AMENDMENTS - 10/05/18

PROPOSED KITCHEN CABINETRY

JOB No: 2018/464
VIEW: PLAN
DATE: JUNE 2018

PROPOSED PLAN

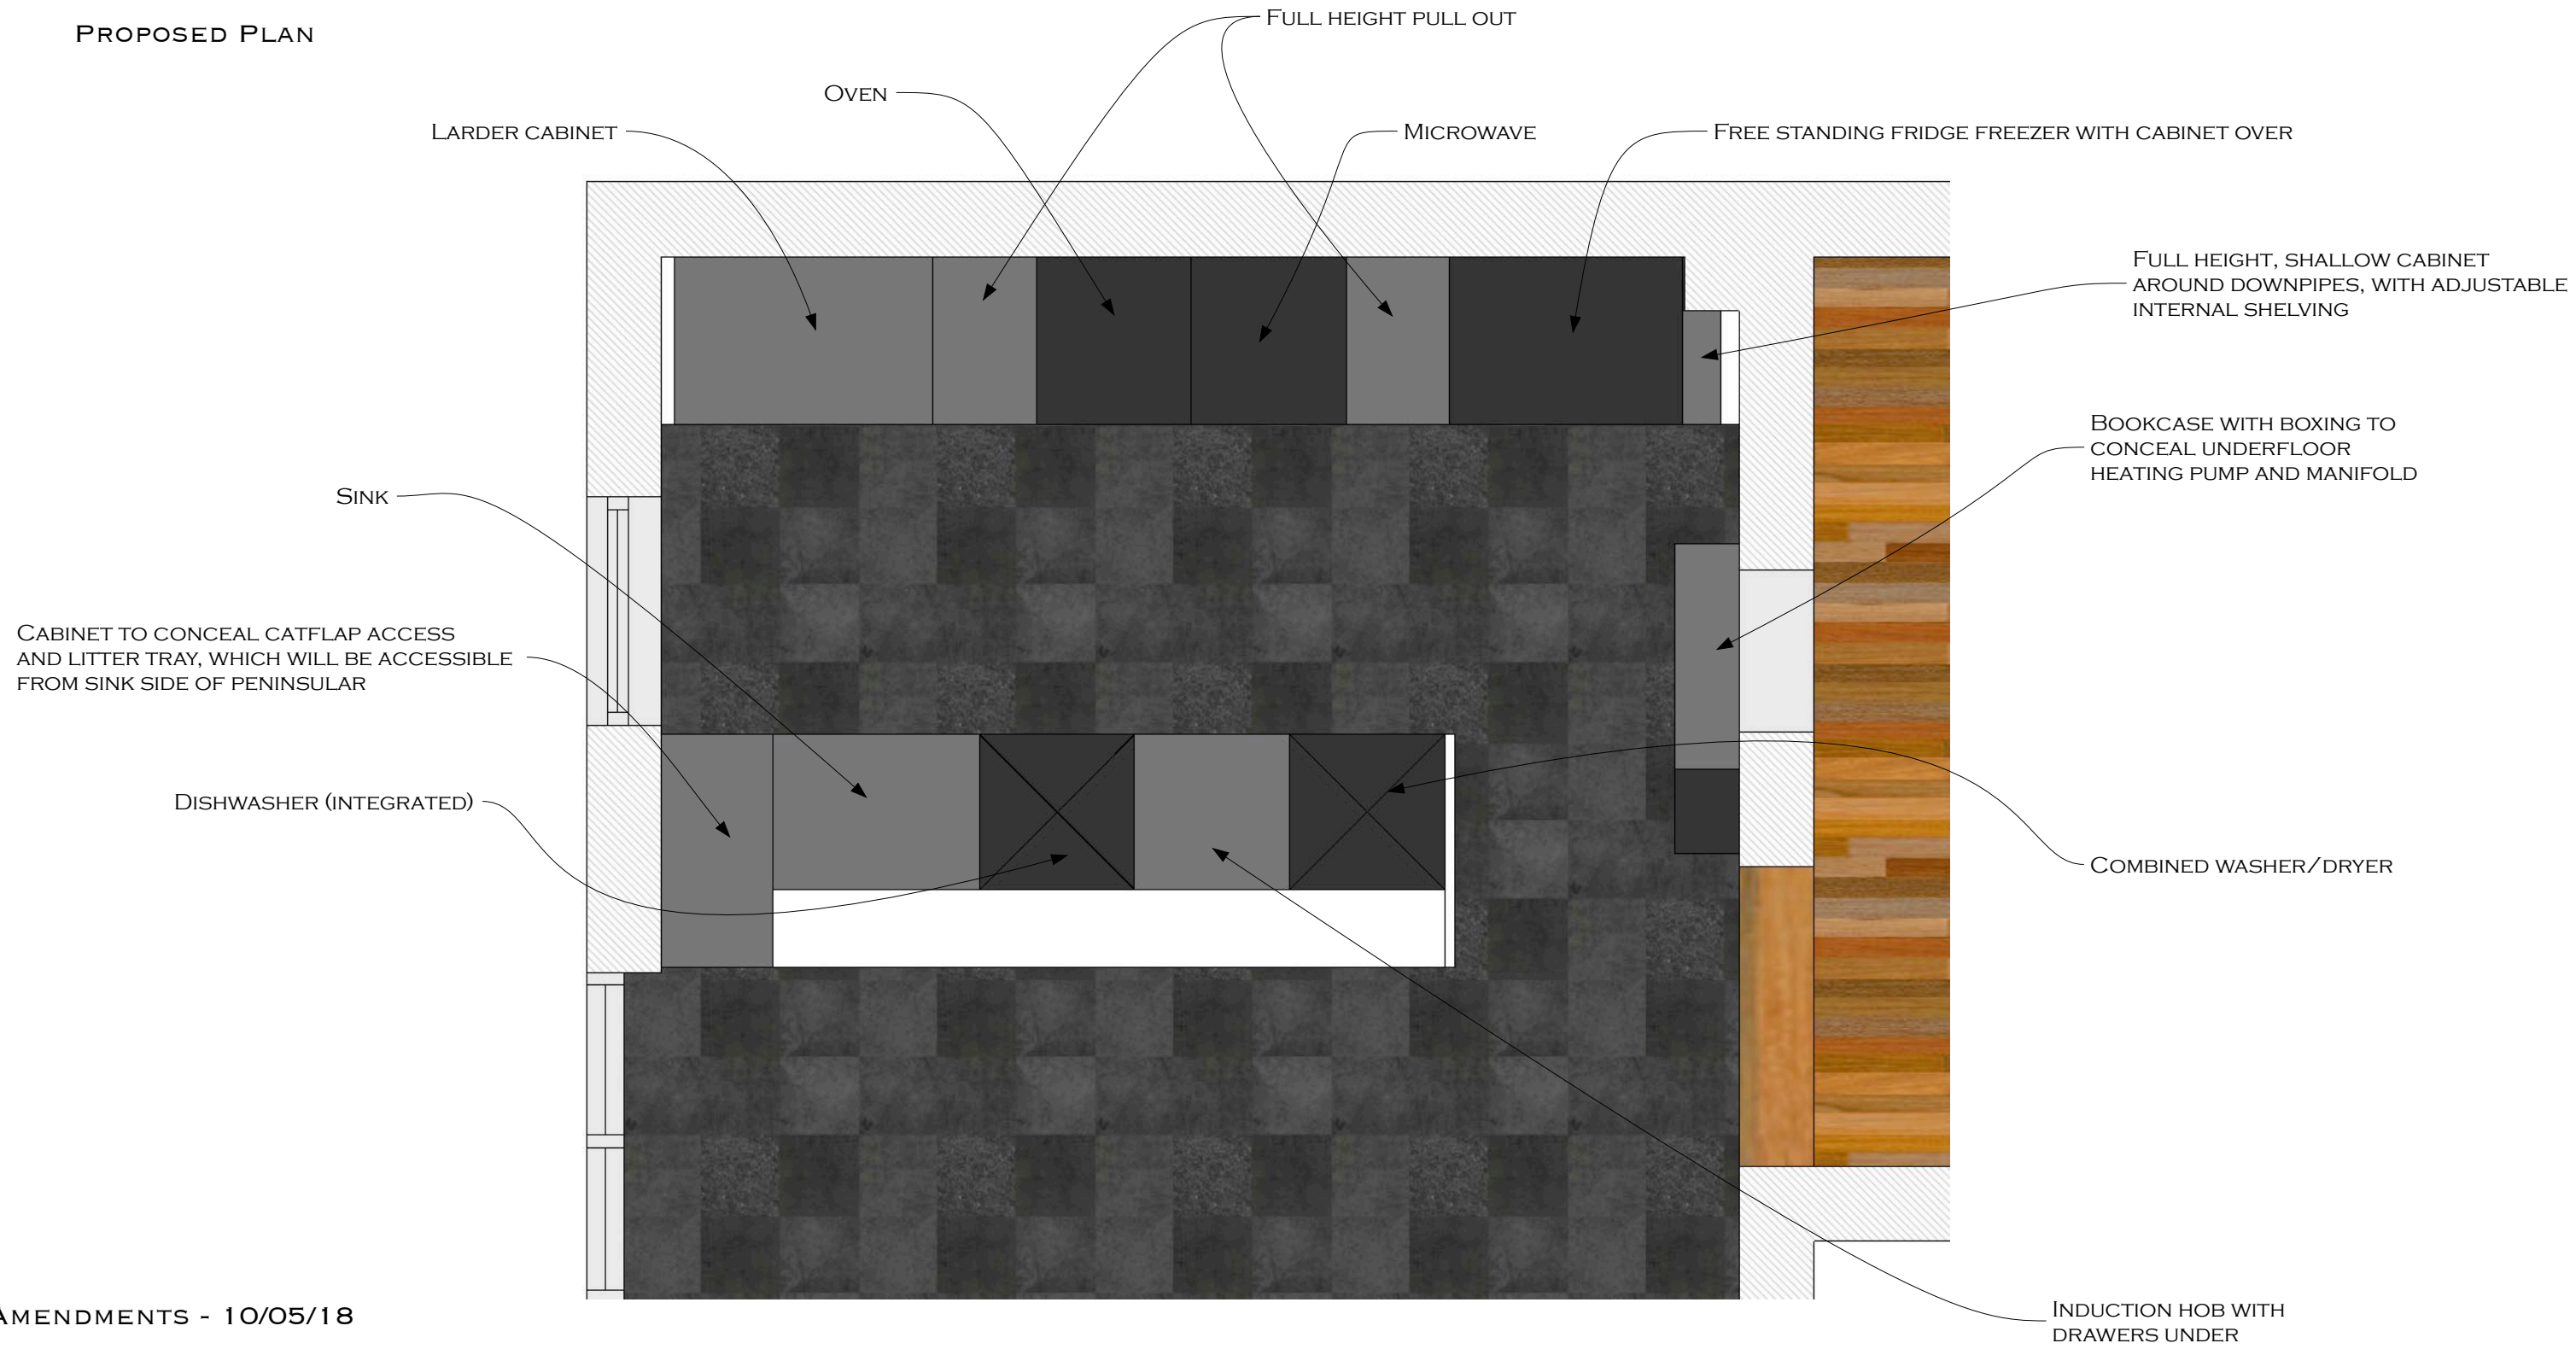
MICROWAVE CHANGED TO SHOW SIZE OF EXISTING, AND DRAWER ADDED UNDERNEATH

CAT FLAP/LITTER TRAY ACCESS AMENDED

SINGLE BOWL SINK REPLACED WITH WIDER 1&1/2 BOWL
